# ADDENDUM

PROJECT TITLE:	Casper College – 2025 Roof Replacements	
PROJECT NUMBER:	2024-83	
OWNER:	Casper College	
ARCHITECT:	Arete Design Group 228 East Brundage Street, Suite 100 Sheridan, WY 82801	
DATE:	March 17, 2025	
ADDENDUM NO:	1	Number of Pages: 06

Drawing sheets HA101, HA401, LA401, CA401 & A410

## ROOF DETAILS

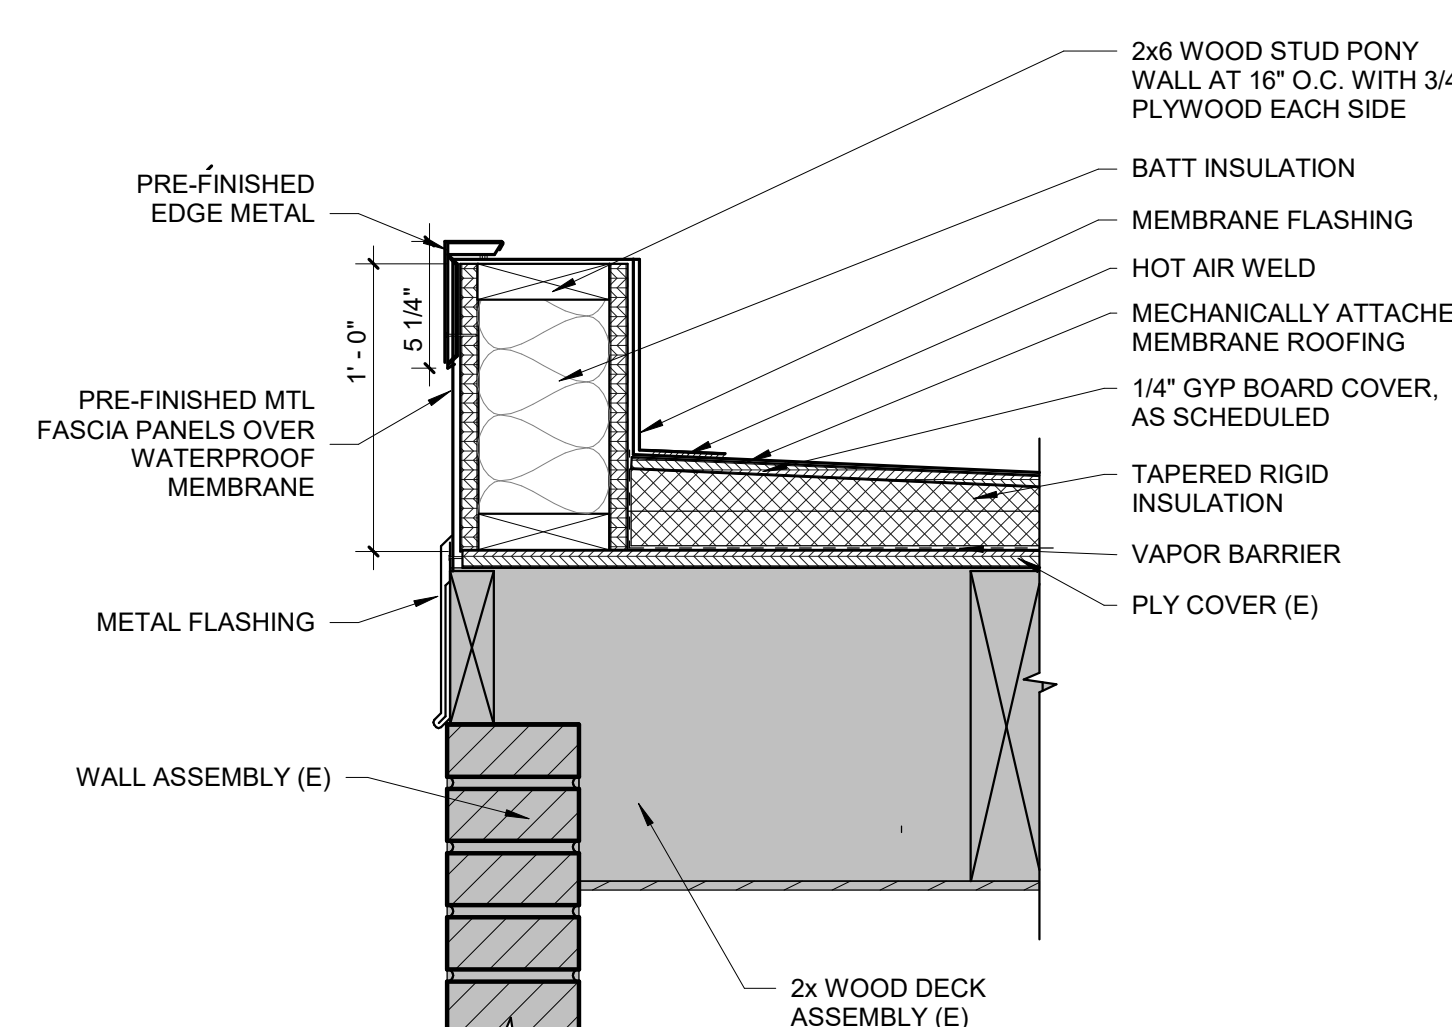
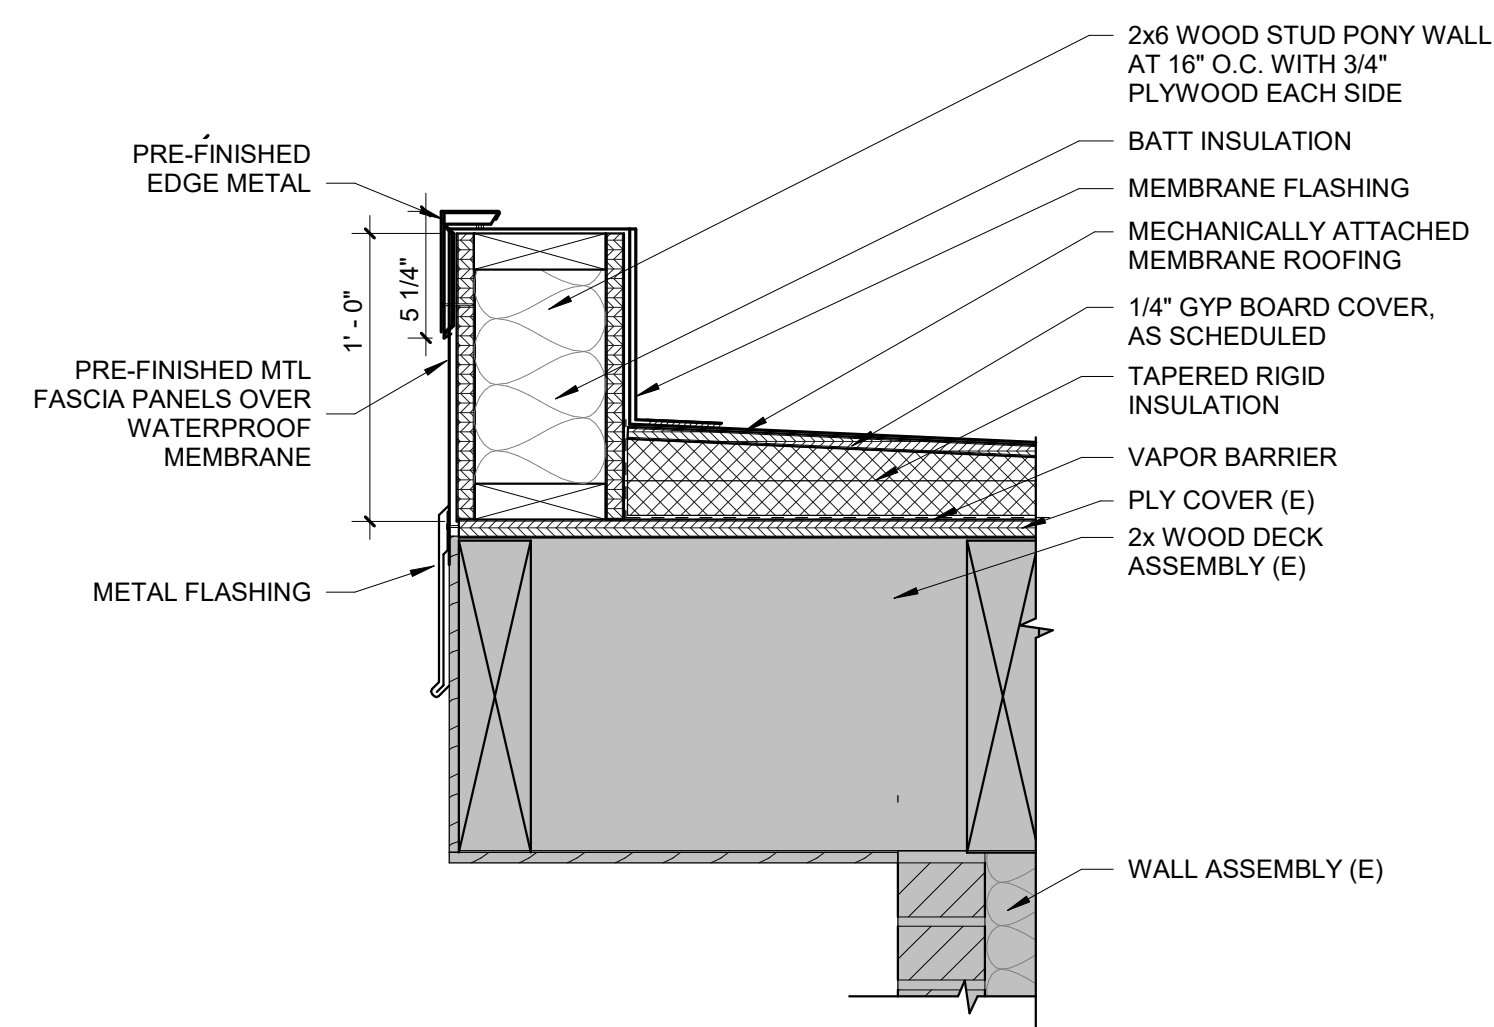
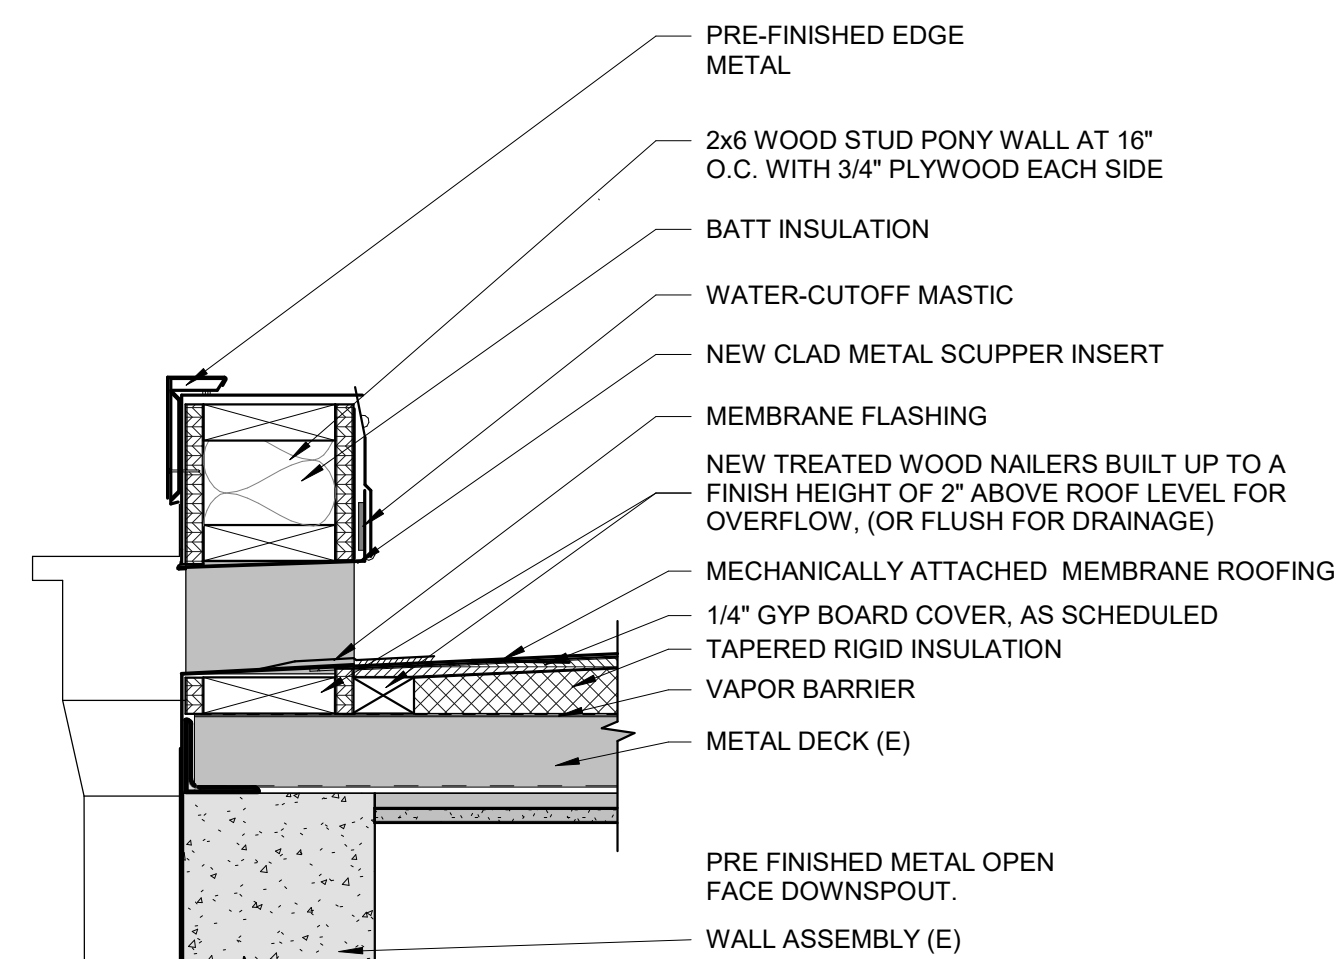
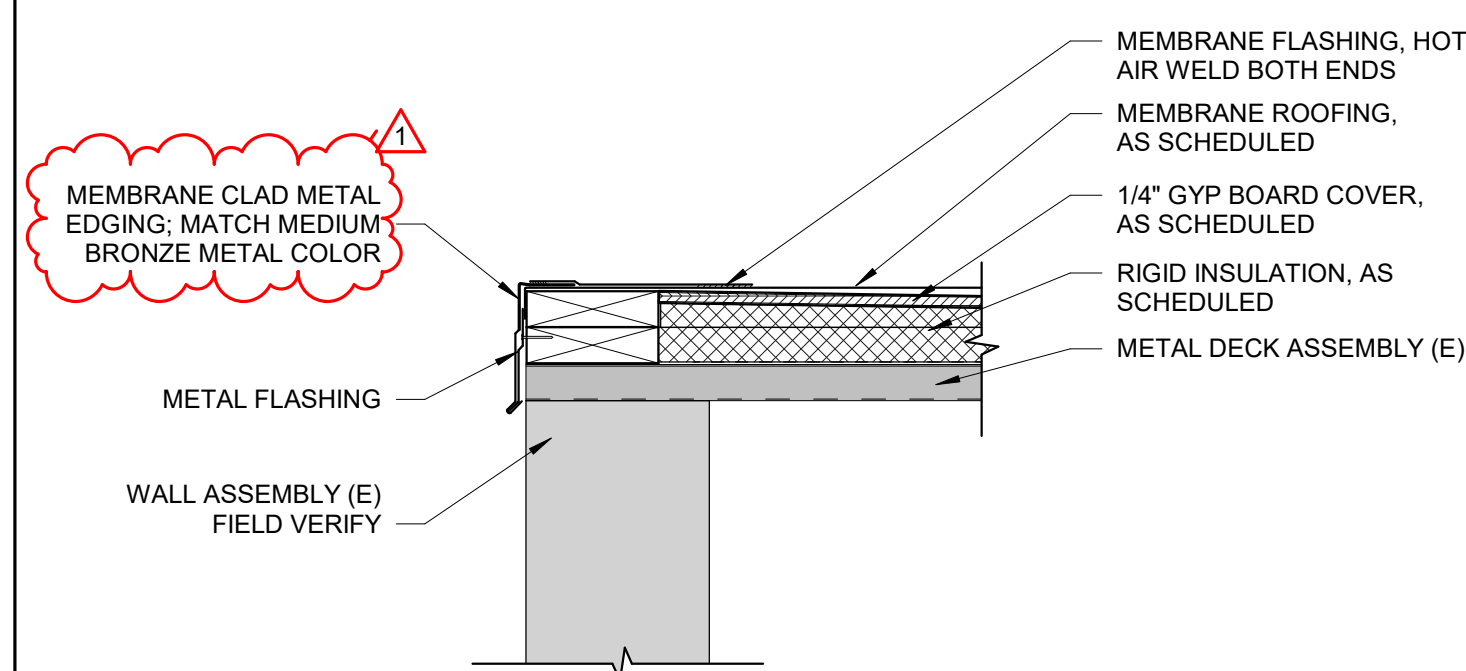
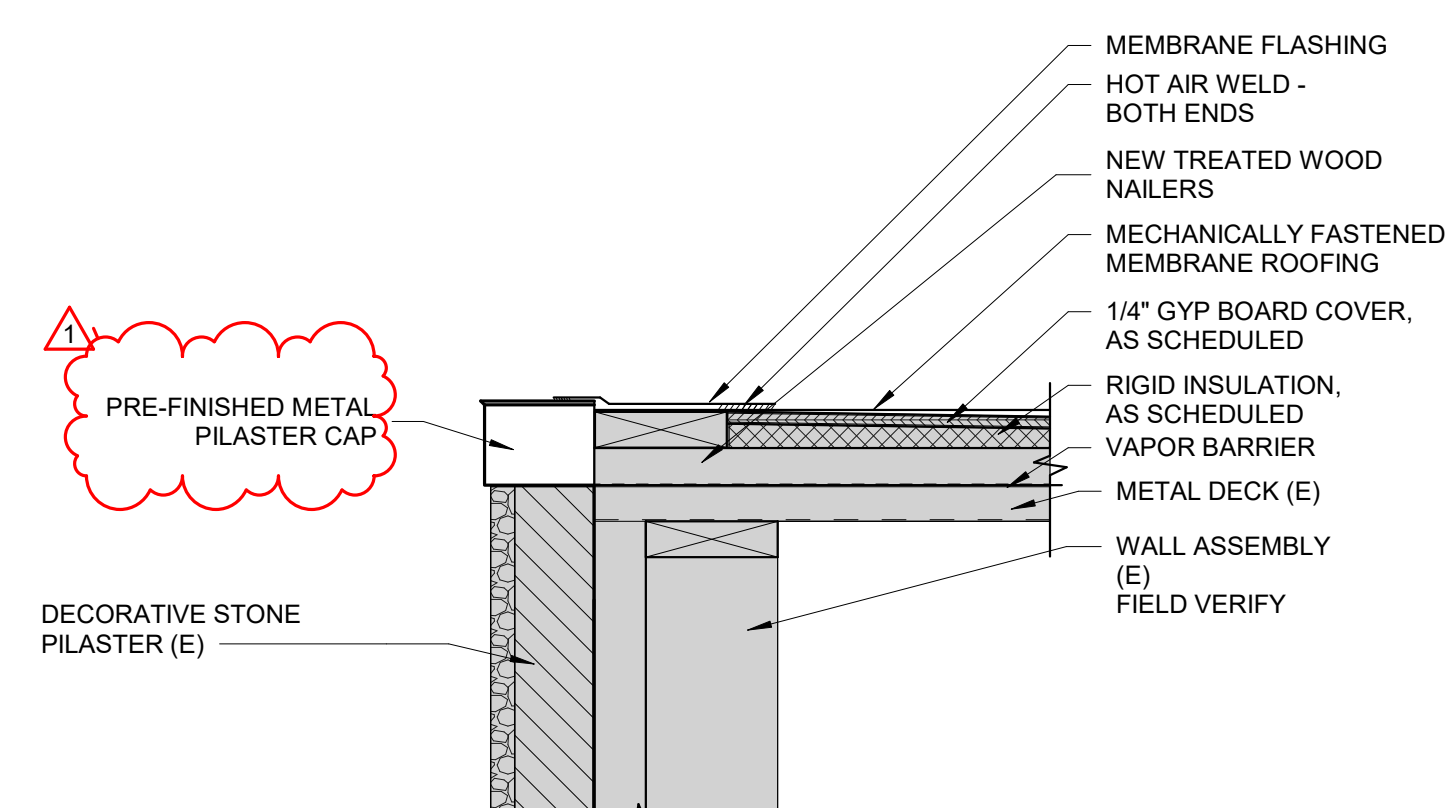
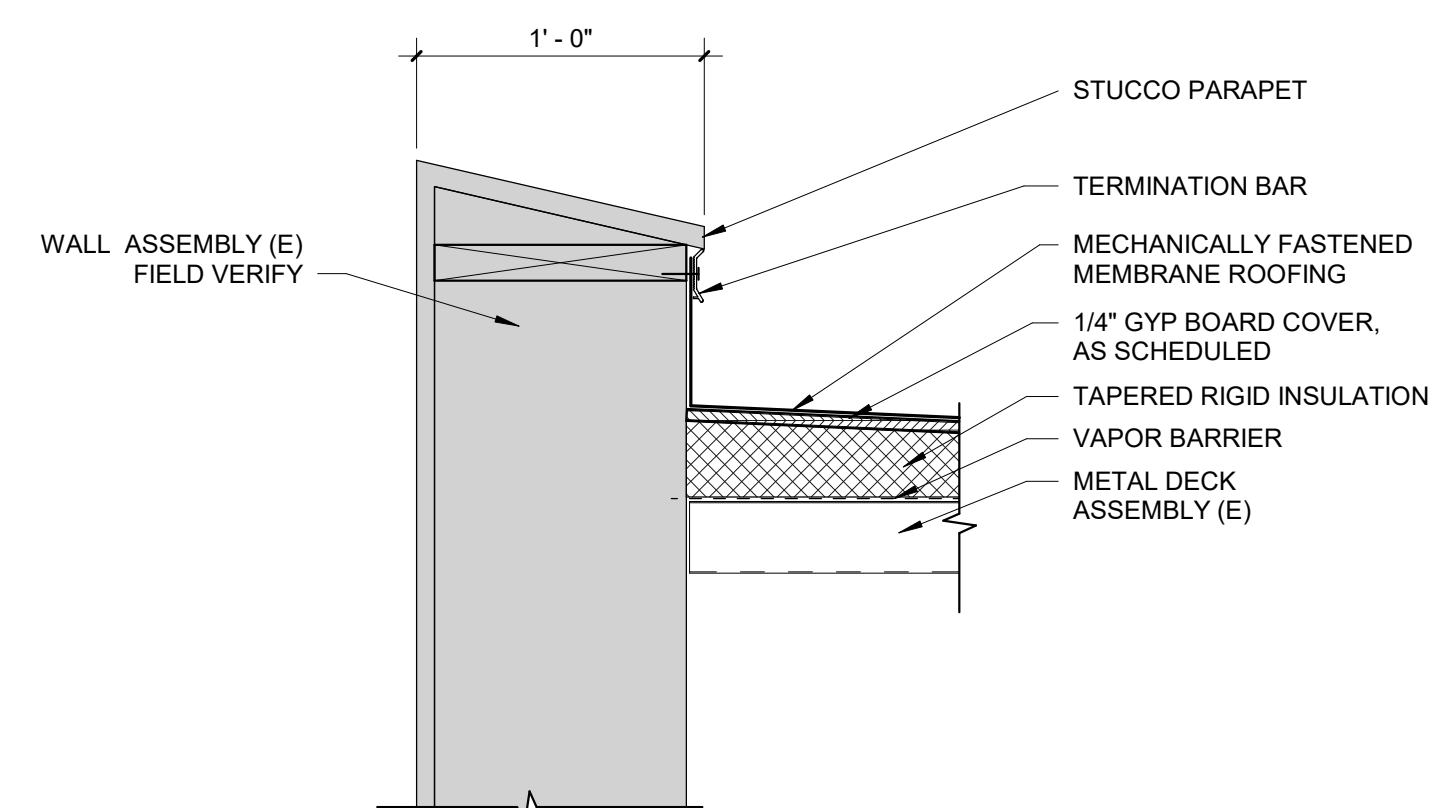
NOTE: DETAILS HAVE BEEN EDITED TO SHOW 1/4" GYP  
COVER BOARD
